Permit Application No.: 15-675

Rules: Erosion Control, Stormwater Management, Wetland Protection, and Variance, after-the fact-permit Waterbody Crossings and Structures

Applicant: Hartman Communities, LLC

Project: Driveway

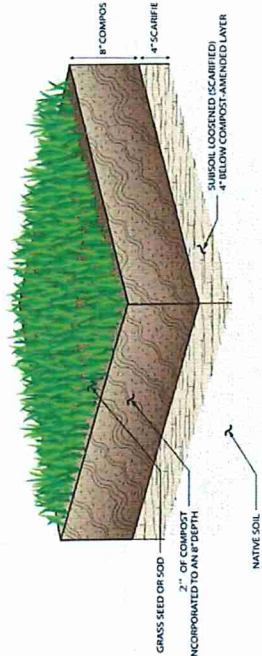
262 contains more wetland species, based on soil moisture conditions, please choose the appropriate mix and reflect on the site plans.

**Response: We have specified on Page 9 that the slopes are to be seeded with Seed Mix 33-261.**

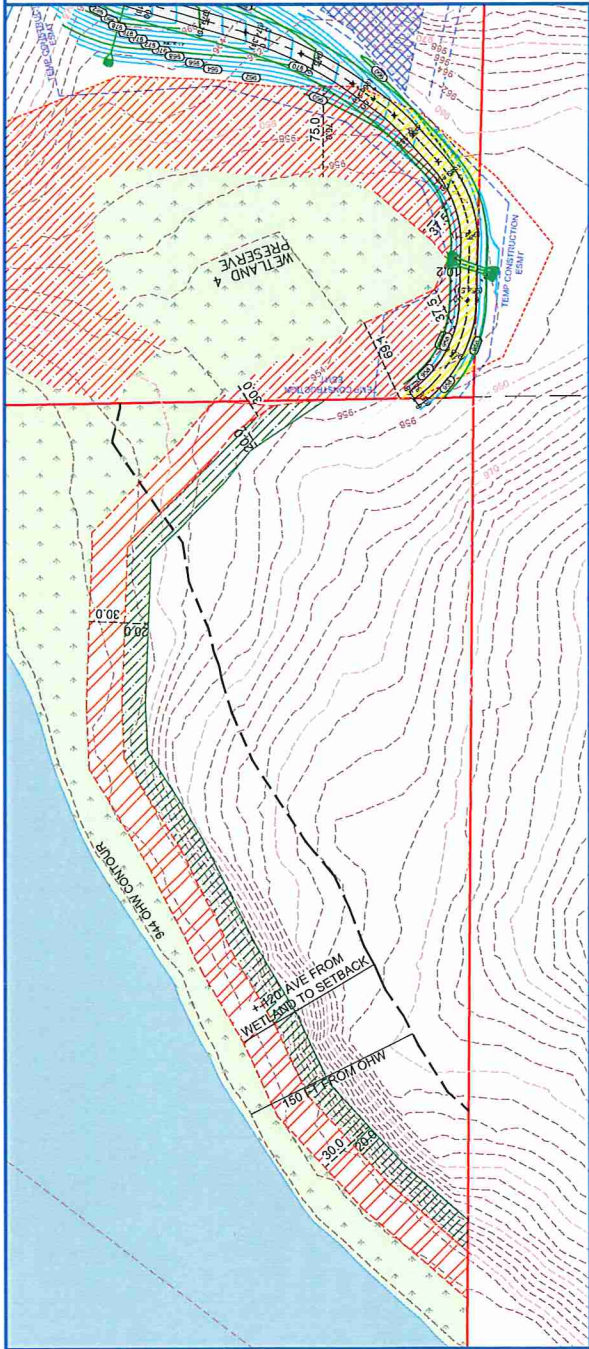
- b. A Maintenance and Monitoring plan that satisfies Section 7(c) of the Wetland Protection rule should be submitted for the areas of the wetland buffer that are going to be temporarily disturbed due to road construction.

Response: We have added page 9A that addresses the monitoring plan.
